CITY OF TULSA
PUBLIC WORKS
Engineering

ADDENDUM NO. 4

ADDENDUM NO. 4
TO
PROJECT NO. 2036W0001Z, 2036A0024Z & TMUA-W 22-37
ARTERIAL STREET RECONSTRUCTION GILCREASE MUSEUM RD. (N. 25th W. AVE.) W. ADMIRAL BLVD. TO W. PINE ST.

ADDENDUM NO. 4
TO
GILCREASE MUSEUM RD.
(N. 25TH W. AVE.)
W. ADMIRAL BLVD TO W. PINE ST.
PROJECT NOS. 2036W001Z, 2036 A0024Z & TMUA-W 22-37

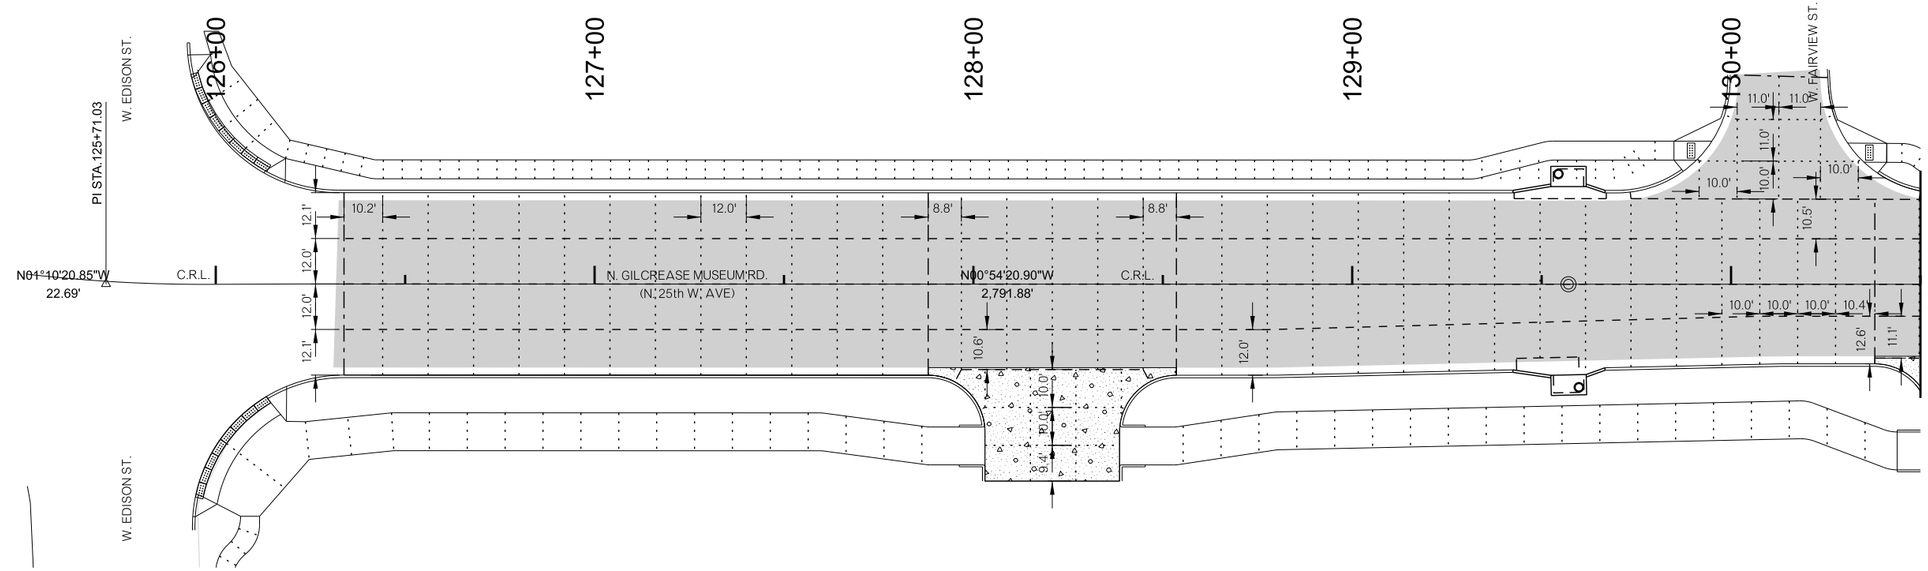
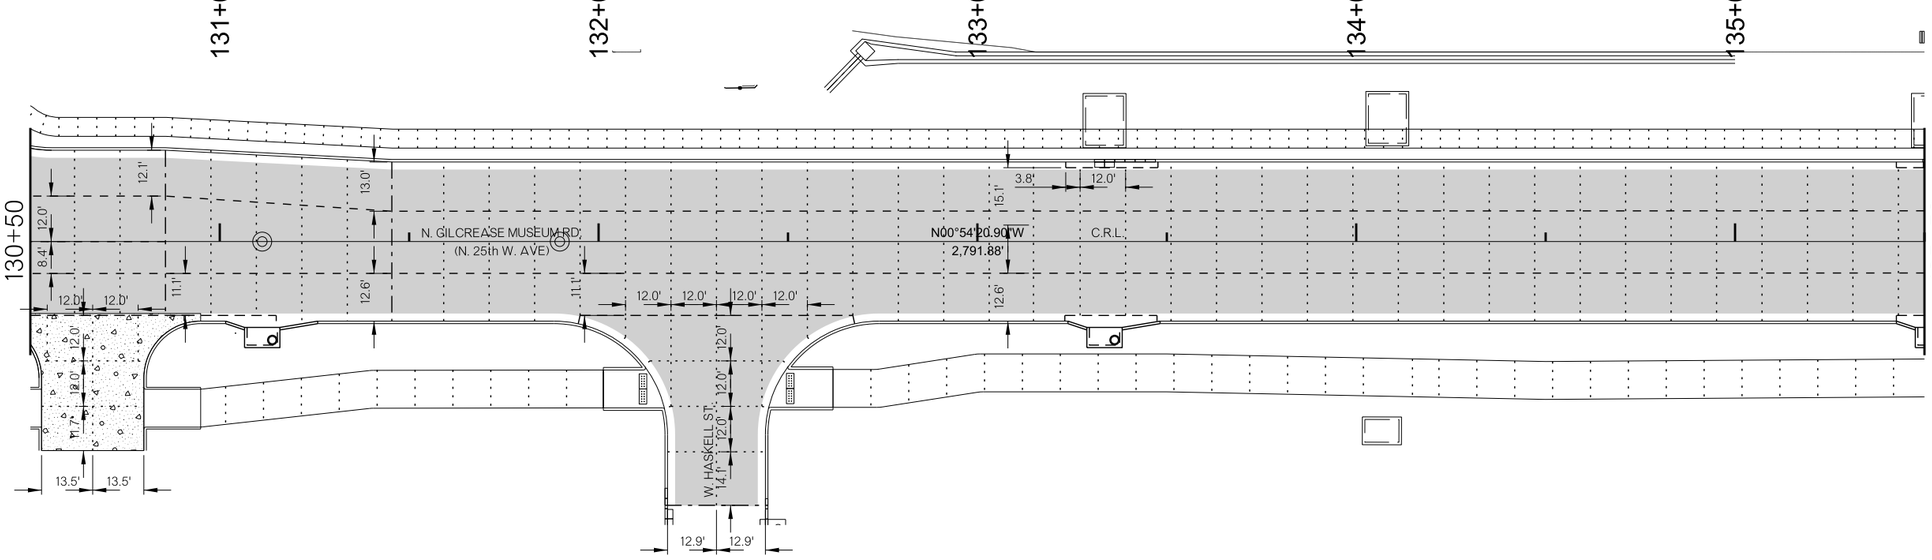
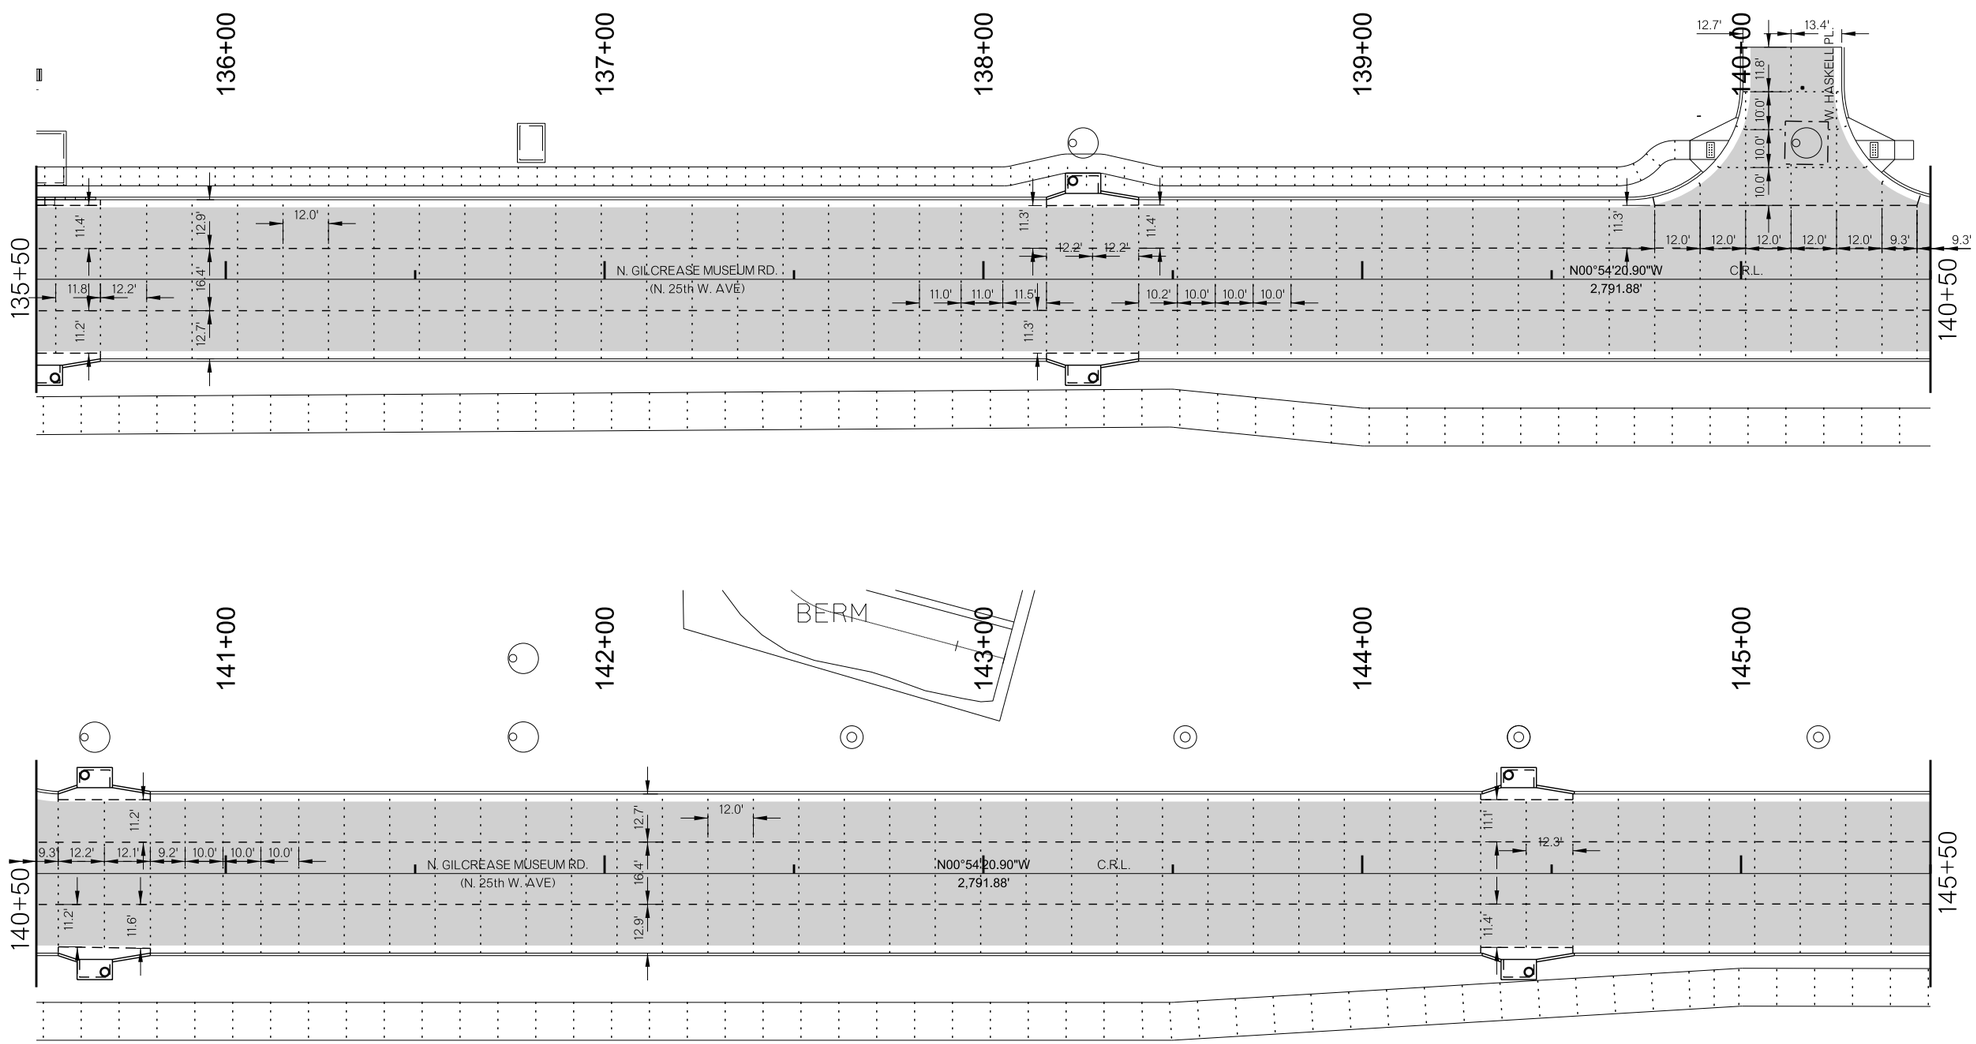
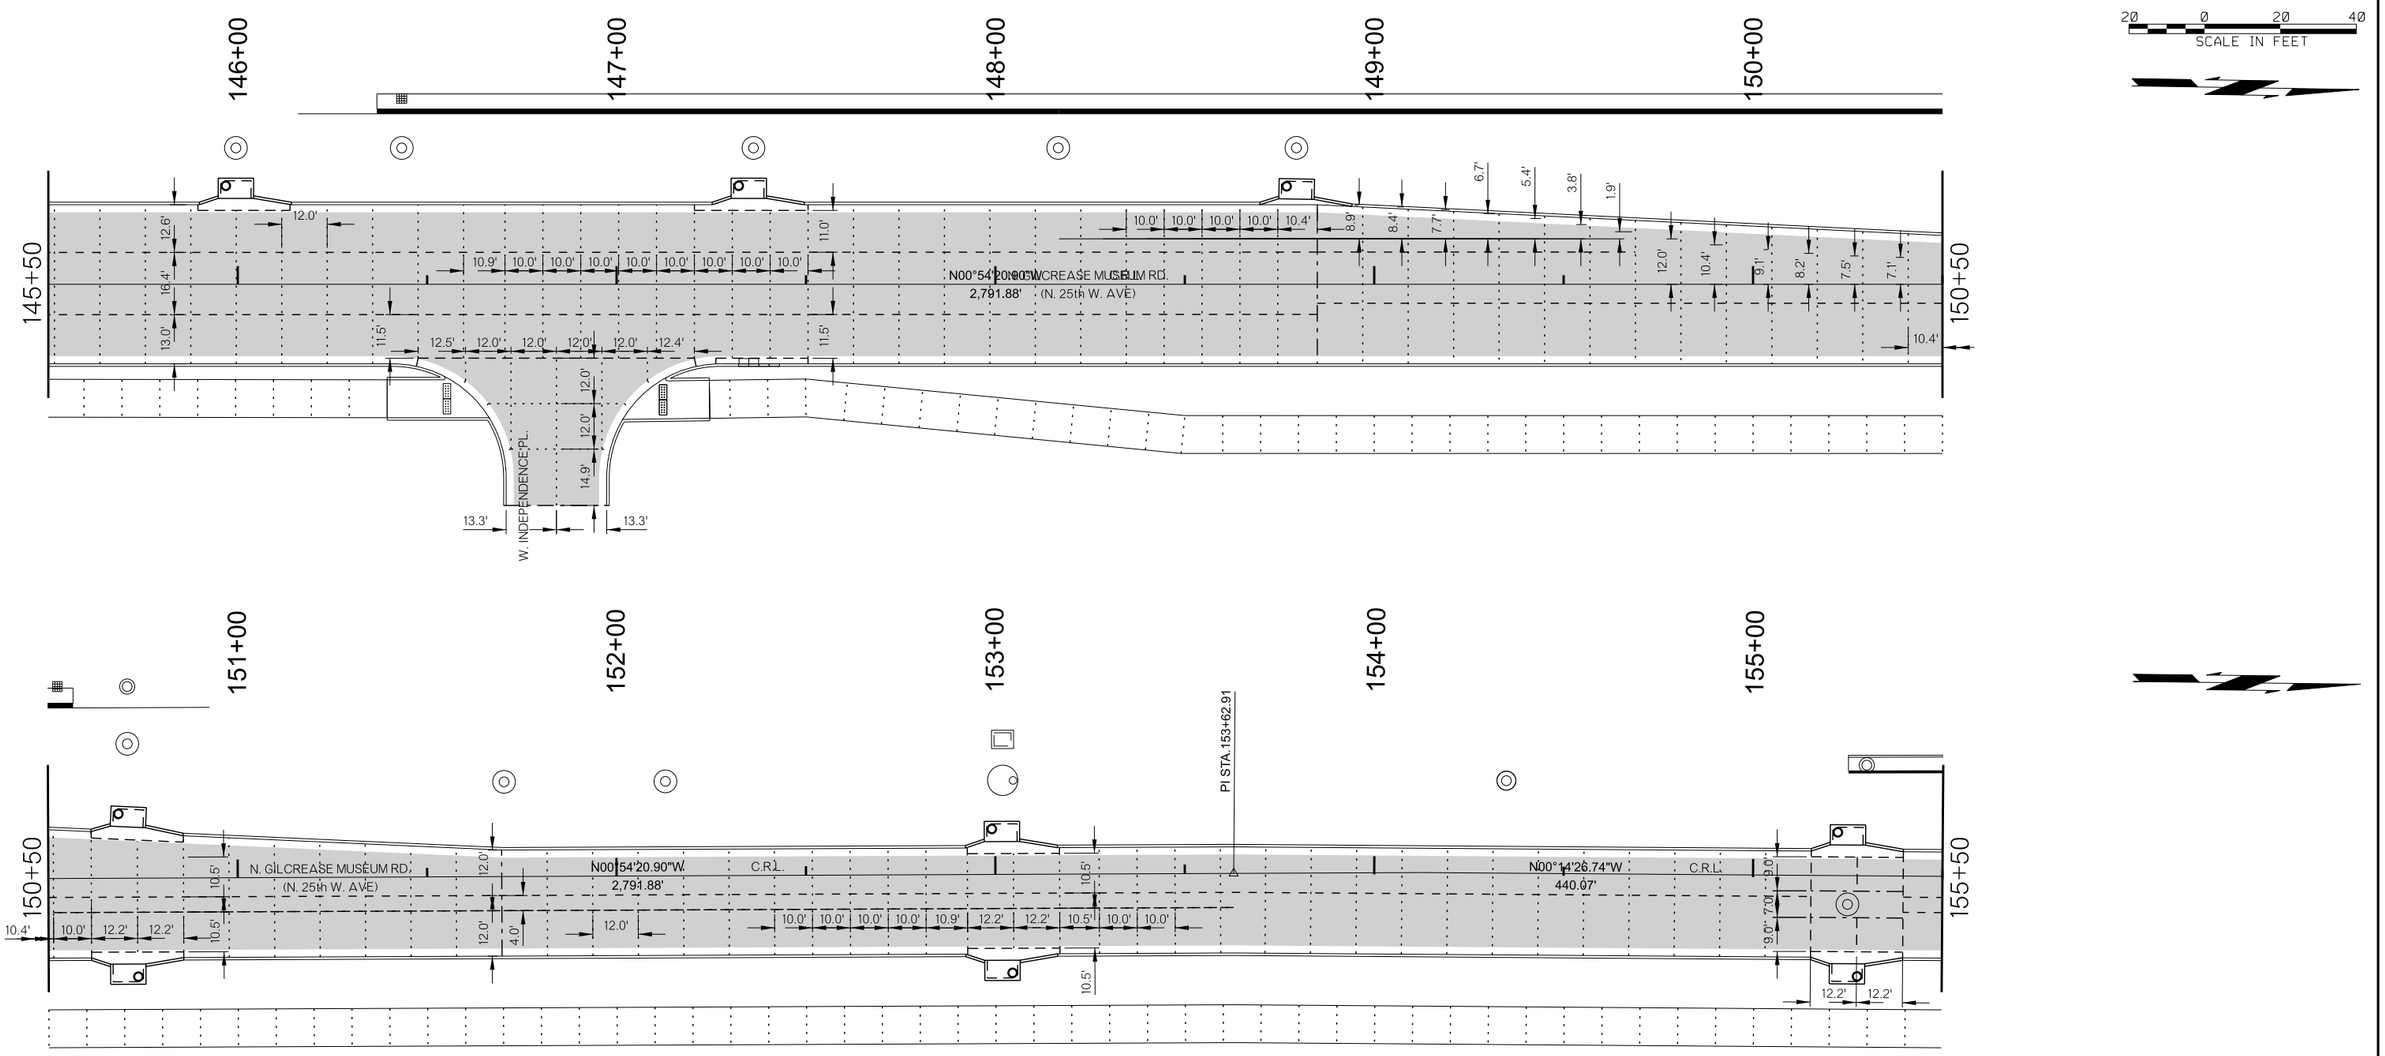
- Nos. 63 to 70 with revised Signing and Striping. Some Trail Signage removed.
- Nos. 71 to 73 with revised Joint Layouts to match striping.
- No. S1 with revised Quantities and Notes.

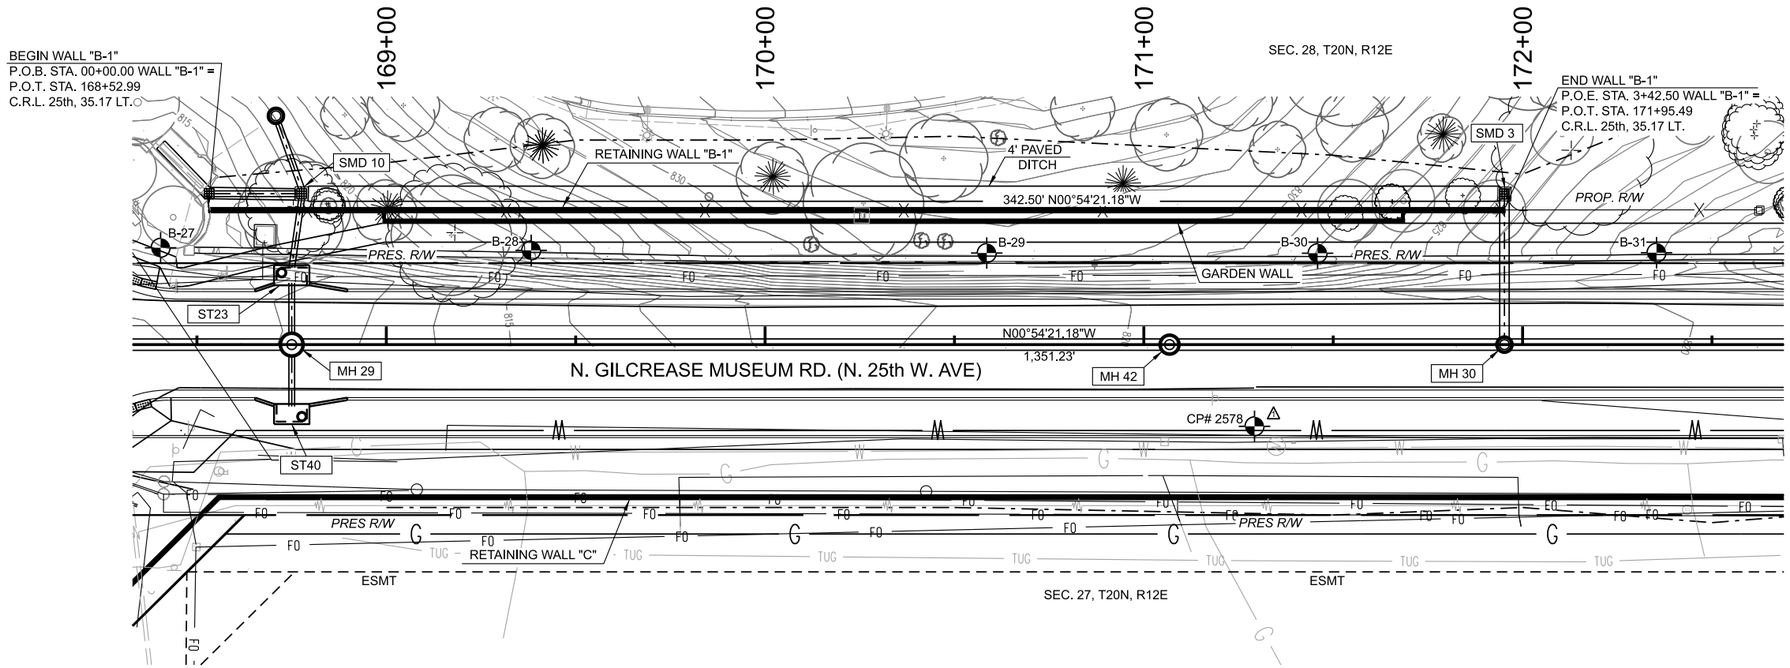
- Deleted Pay Item 133 STRUCTURAL STEEL.
  - Added Pay Item 218 PILES FURNISHED.
  - Revised Quantity of Pay Item 141 from 893 LF to 892 LF.
  - Revised Quantity of Pay Item 142 from to 1038 LF to 1039 LF.
